RE: Marathon Watch Company amendment request for E- Distribution License No. 54-28516-01E, and Certificate Registry No. NR-0505-D-101-E, to add a new Wrist Watch Model. PLEASE NOTE: THIS MODEL EMPLOYS A MINOR CHANGE TO AN EXISTING WATCH (MODEL # WW194013)

MODEL: WW194013SS

## APPEXDIX A:

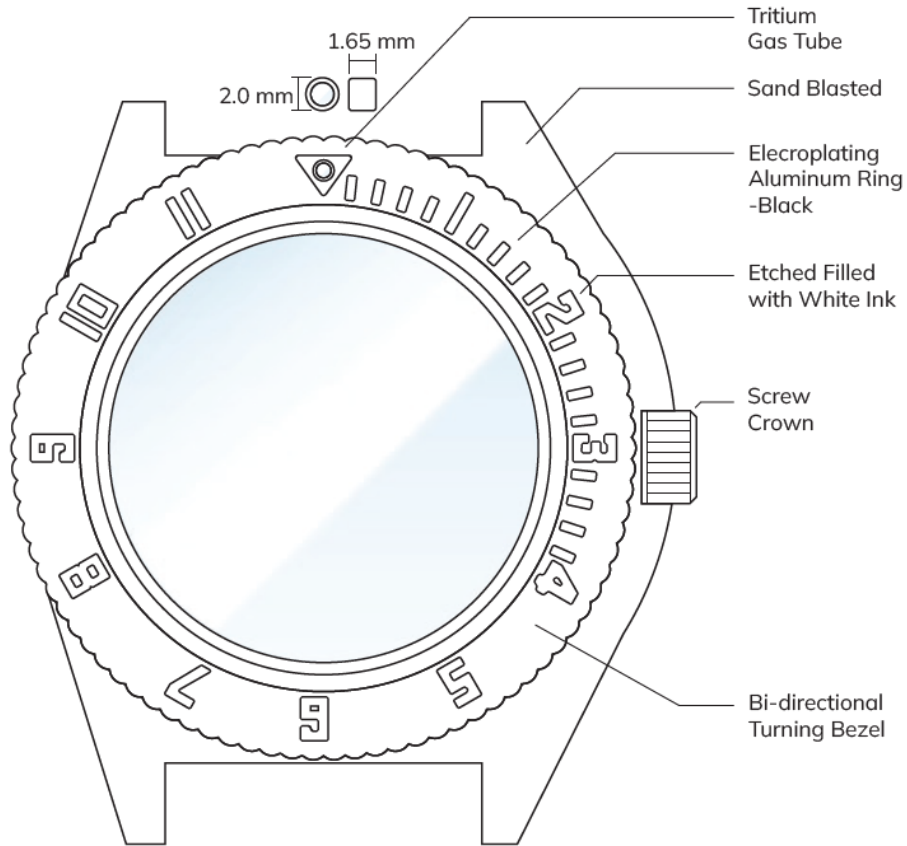
NOTES:  
The usage and application is the same as MODEL # WW194013. The only change is with the bezel tube, which is now SSMD # T 5489 and is inserted into drilled cavity in the bezel (See Appendix A) and held in place by a special two components glue (ARALDITE 2020). This was the same glue that is used to adhere the tubes to our dials of the existing models. These changes will not affect the testing result of the standard MODEL # WW194013.
